Bylaw 20613

A Bylaw to amend Bylaw 17270, as amended,
being the Riverview Neighbourhood 3 Neighbourhood Structure Plan

**BYLAW 20613
AMENDMENT TO
RIVER'S EDGE
Neighbourhood
Structure Plan
(as amended)**

Development Concept

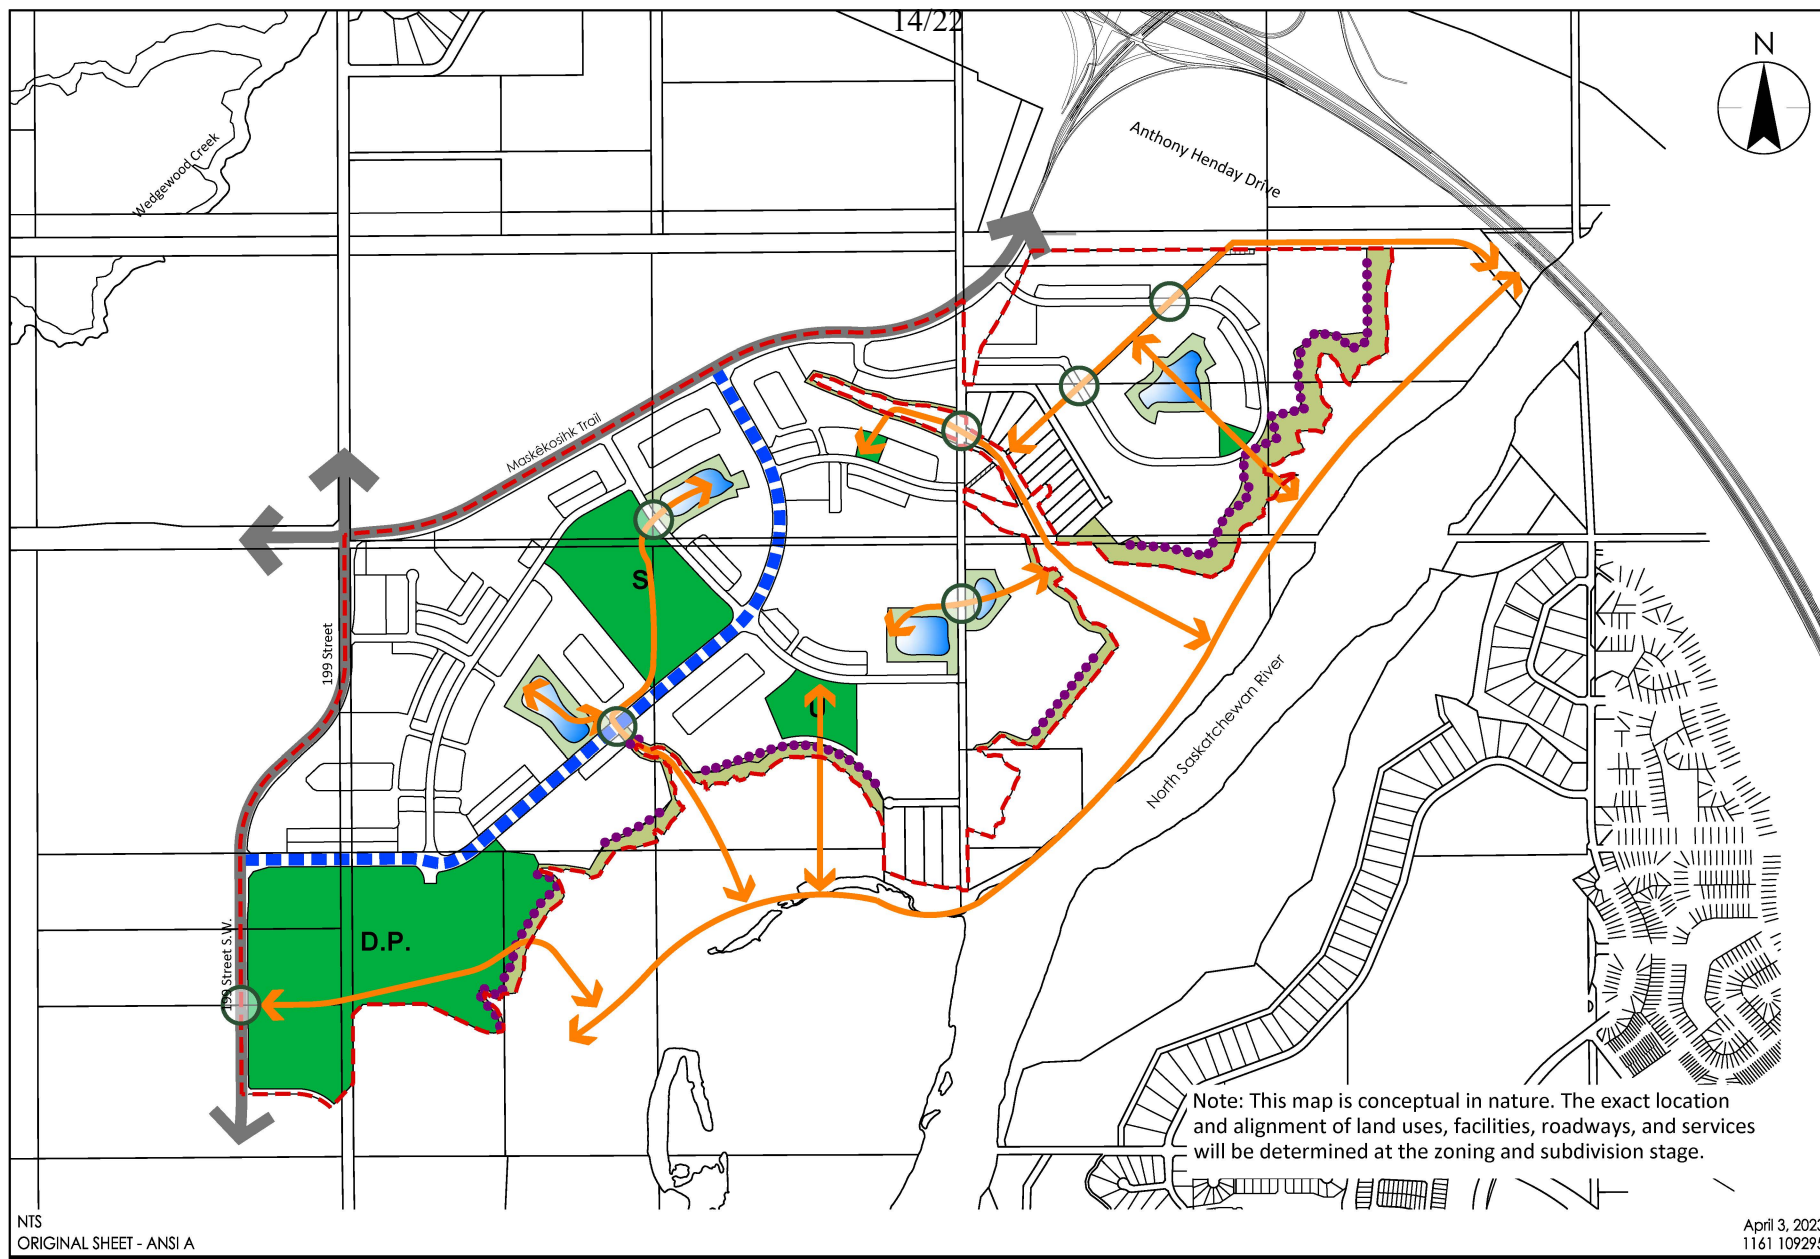
“Both the District Park and Urban Village Park are located abutting the top-of-bank and top-of-bank roadway in the southeastern boundary of the plan area (Figure 5: Development Concept) and provide points of entry or staging areas for residents and visitors to access the river valley and its trails directly from the neighbourhood.”;

- oo. Deleting “Figure 5 – Development Concept” and replacing it with “Figure 5 – Development Concept”, attached hereto as Schedule “C” and forming part of this bylaw;

Transportation

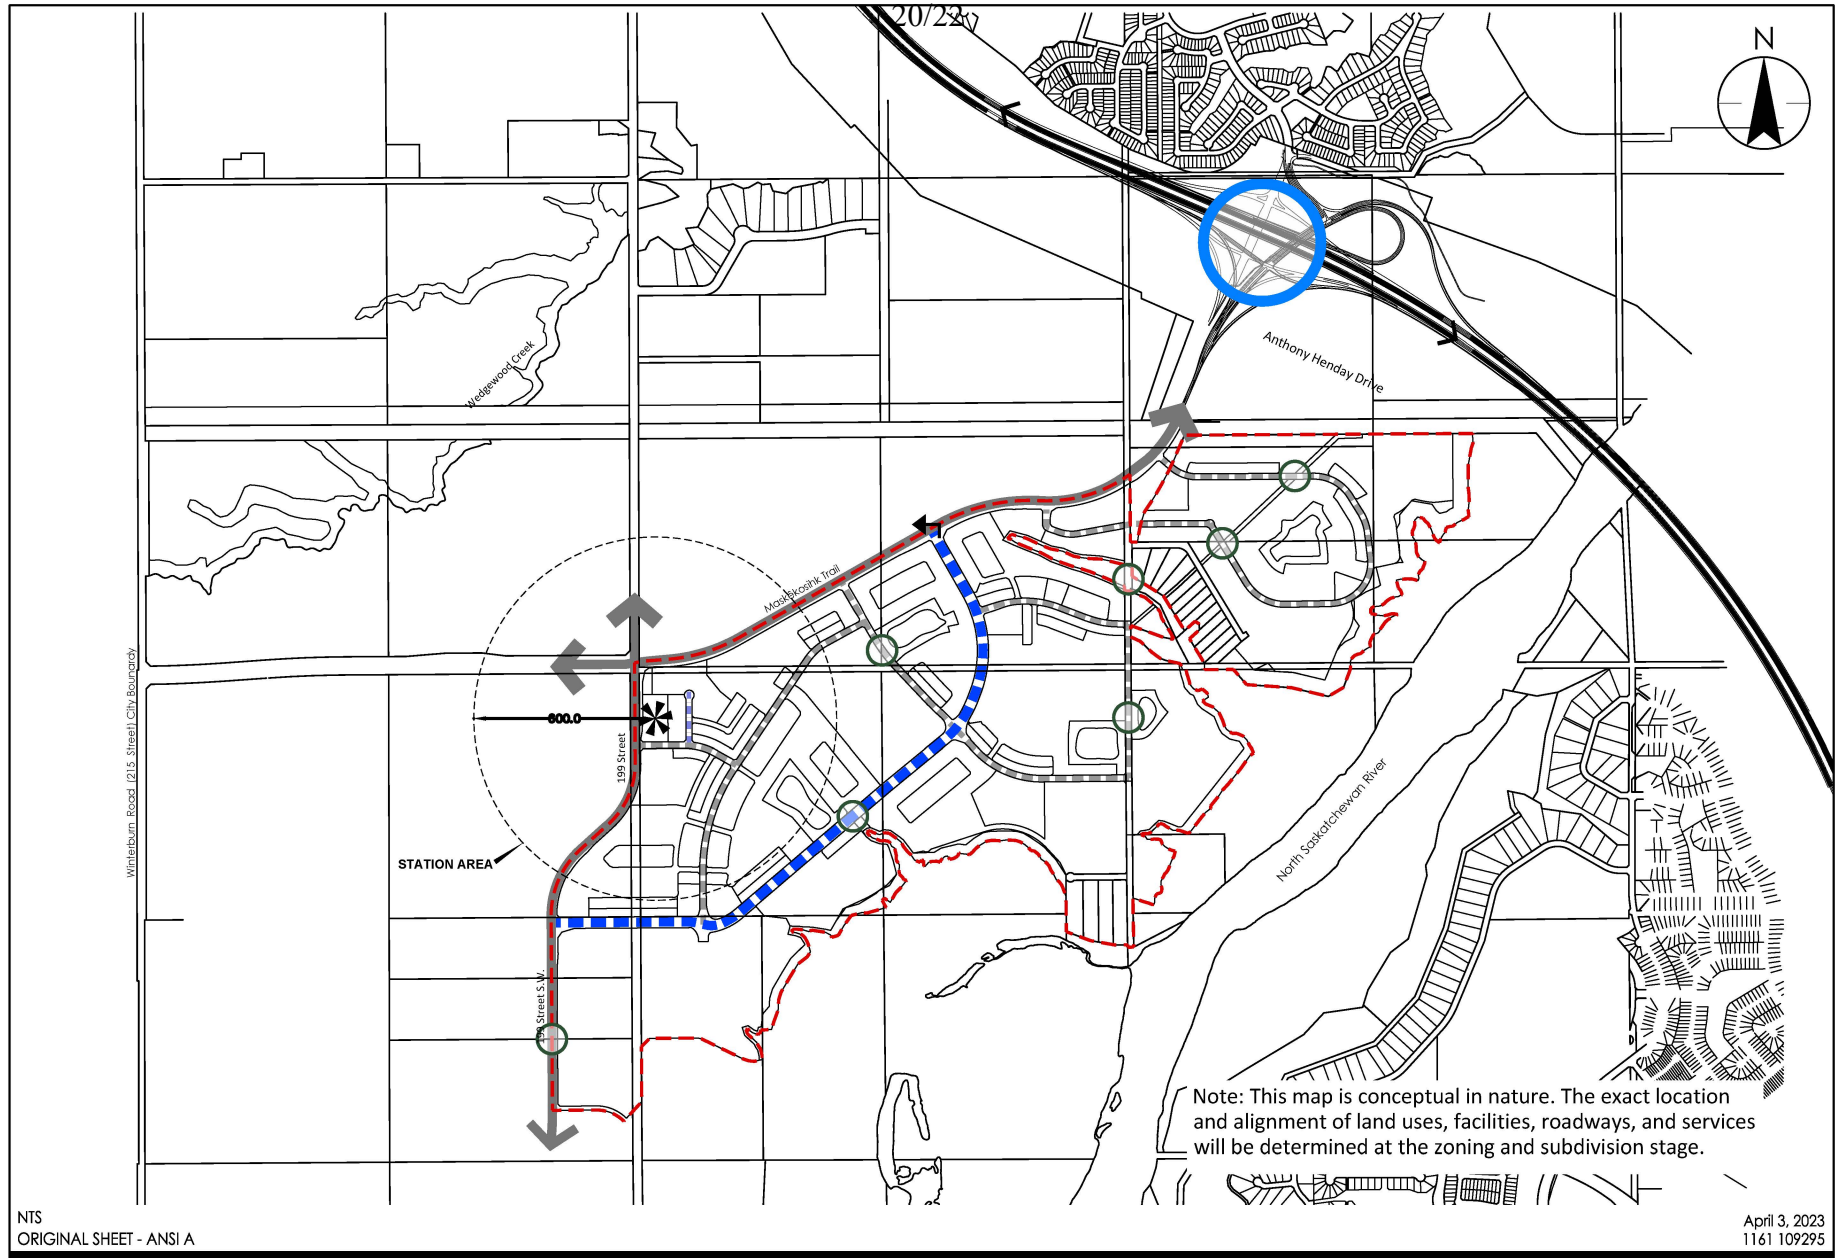
Riverview Boulevard is proposed to intersect Maskêkosihk Trail at a T-intersection. The northbound to westbound left-turn movement at the Maskêkosihk Trail/Riverview Boulevard intersection will be permitted onto Maskêkosihk Trail on an interim basis (as identified on Figure 12: Transportation Network). Such left-turn movement shall be removed when Maskêkosihk Trail is upgraded from a 2-lane to a 4-lane roadway, or when alternate access is provided which accommodates the northbound to westbound left turn movement, or when merited by deficient levels of service along Maskêkosihk Trail, whichever comes first, at the discretion of Transportation Services. The function and design of Maskêkosihk Trail and 199 Street area will facilitate way-finding and priority pedestrian crossings across 199 Street and Maskêkosihk Trail (see Figure 13: Active Mode Transportation Network).

Active Mode Transportation

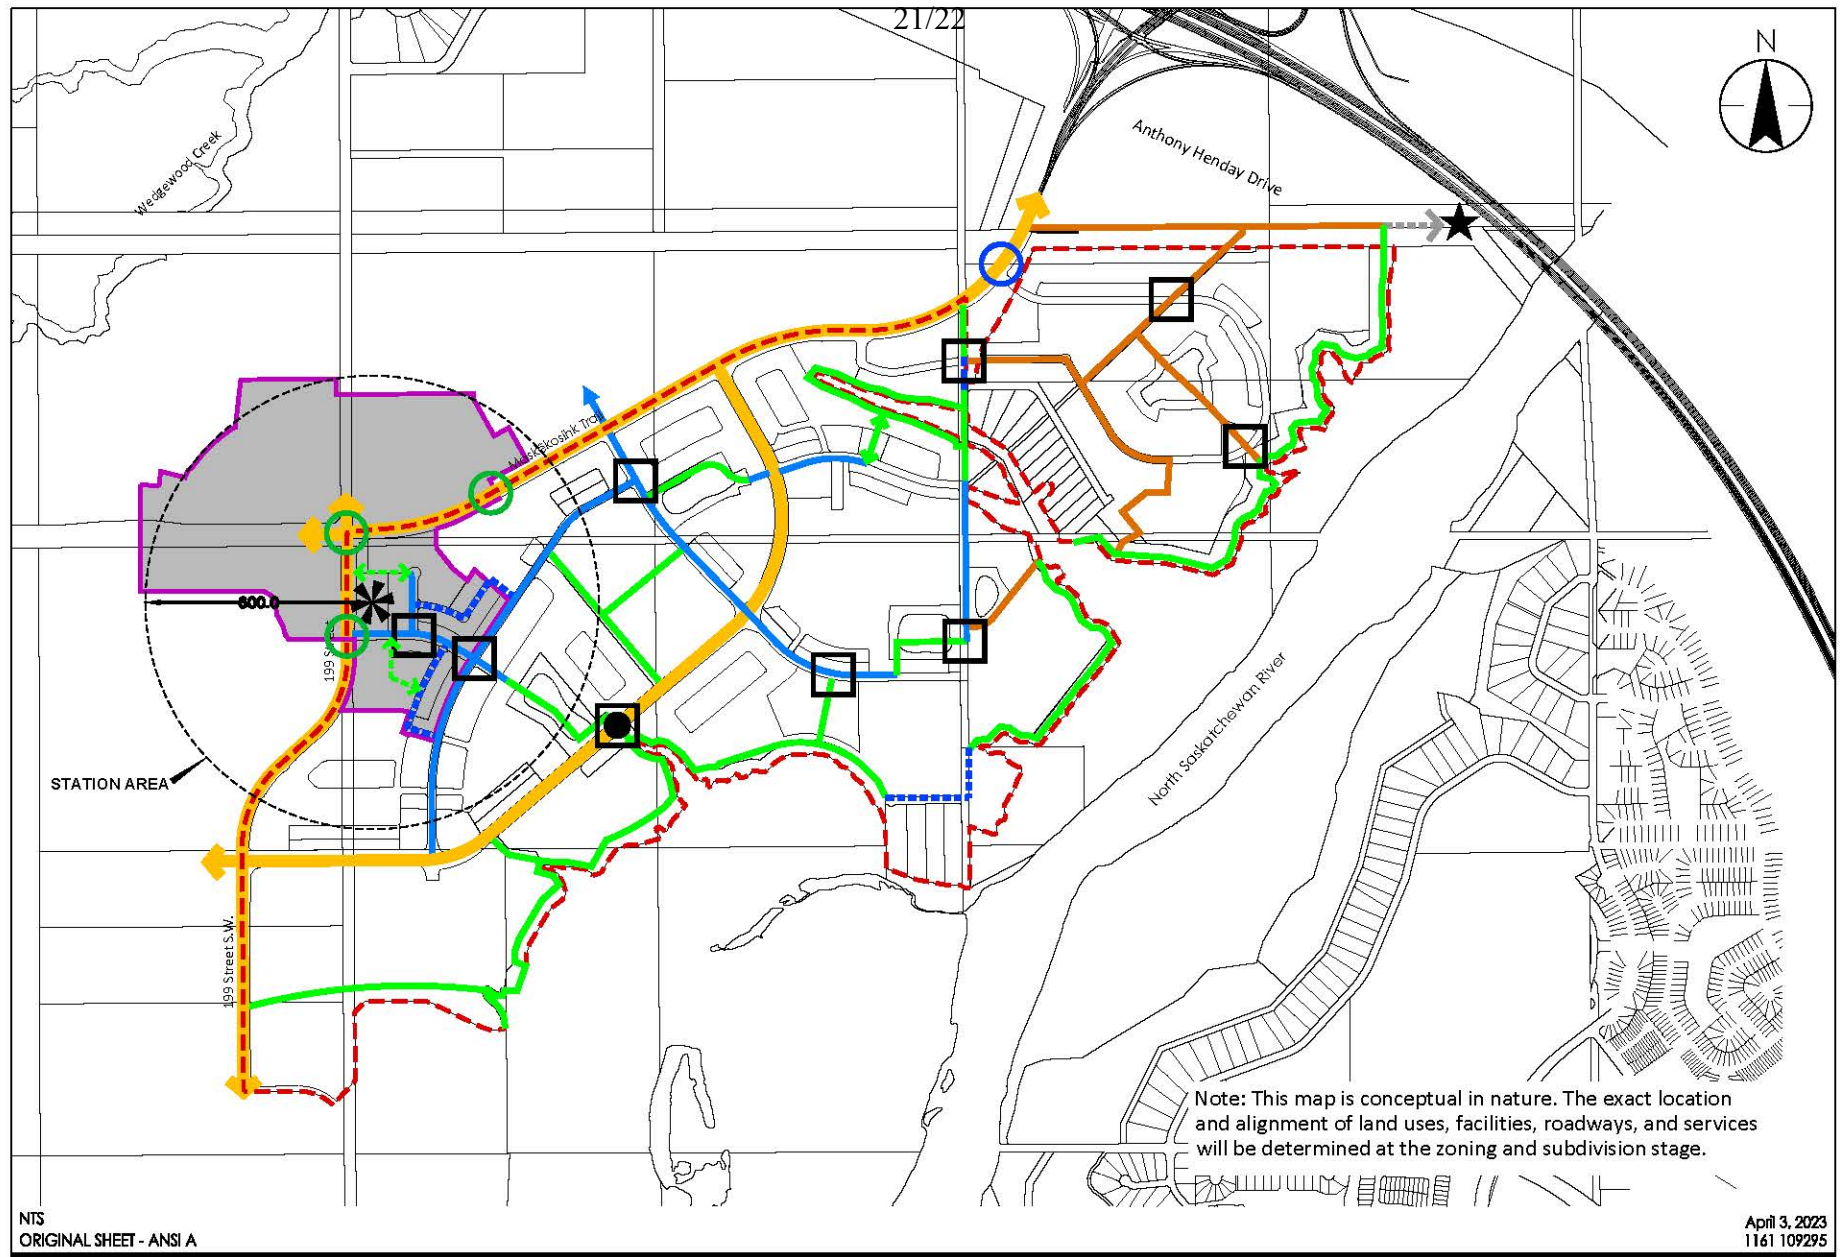
“ The active modes network illustrated in Figure 13: Active Mode Transportation, identifies a connected network that will utilize options such as shared use paths, shared roadways, road rights-of- way, parks and open spaces, walkways, and access easements, where identified and contextually appropriate, to connect residents with key destinations within River’s Edge and surrounding neighbourhoods.

Pedestrian permeability through the pedestrian zone, generally as identified in Figure 13, will be provided on road right of way or via walkways per the Complete Streets Design and Construction Standards to include a walkway and other aspects such as lighting, intermittent access points, and other details to promote a safe and inviting space.”;

“Tiers of active mode facilities in public right-of-way have been identified on Figure 13: Active Mode Transportation (in addition to connections in park/open space, public utility lots, and easements) to clarify the type of facility to be provided. Active mode connections can be achieved through a range of facilities, including shared use paths, sidewalks, walkways, or on-street markings, with the type provided to be contextually appropriate and with consideration for the overall active transportation network.”;
- jj. Deleting number 5. after the second paragraph in Section 8.3 “Active Modes Network, Objective 40”, and replacing with the following:

- ll. Deleting the first sentence in the last paragraph, in Section 8.3 “Active Modes Network, Objective 40, Implementation” and replacing with the following:
 “Figure 13: Active Mode Transportation Network shall guide the future application of walkways, sidewalks, greenways, shared roadways, and shared use paths.”;
